City of Madison, Wisconsin

REPORT OF: URBAN DESIGN COMMISSION **PRESENTED:** August 20, 2014

TITLE: 202 East Washington Avenue –
Redevelopment of the “Pahl Tire” Site for
a 10-Story, 146-150 Room “AC Hotel by
Marriott” in UDD No. 4. 2nd Ald. Dist.
(33109)

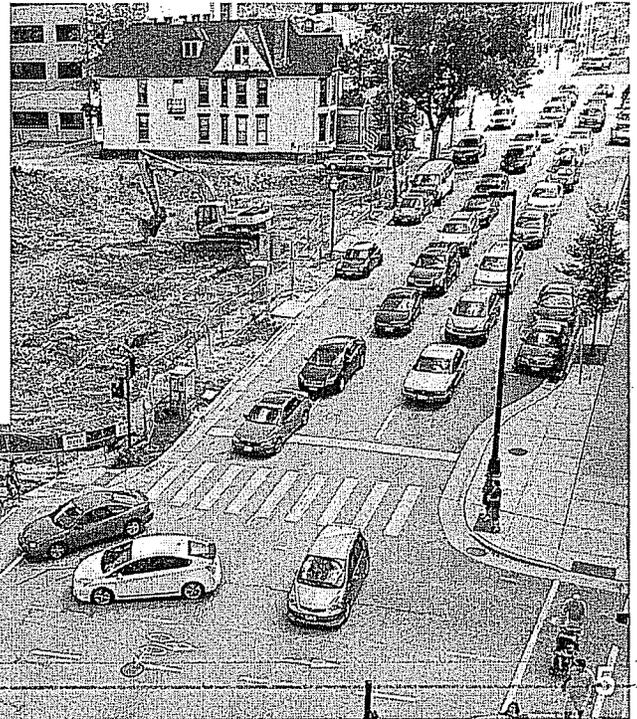
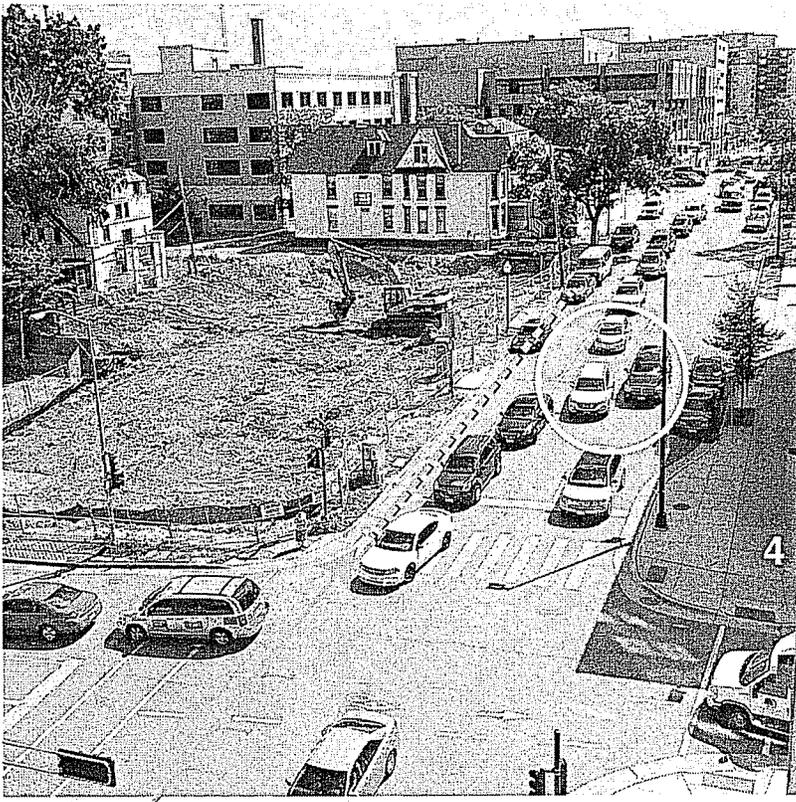
4:42 pm
Capitol North Ramp full.
A waiting car cannot enter
ramp until one leaves,
backing up Mifflin traffic
onto Webster.

6:58 pm
Cars going straight
(North) on Mifflin block
oncoming traffic on
Webster.

7:00 pm
Cars approaching on
Webster cannot and
should not get into right
turn lane when bicyclists
are present. Cars going
straight behind them are
blocked.
Bicyclists approaching
intersection from all
directions are always in
danger.

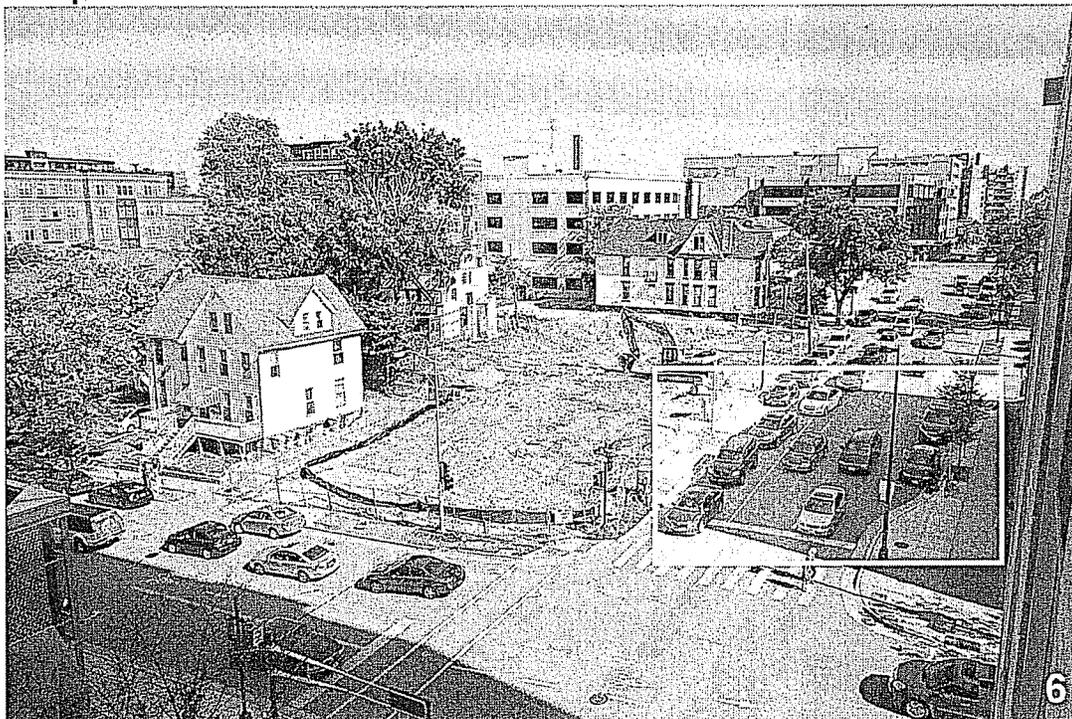
More honk-worthy moments

How much of this
area will remain
No Parking?
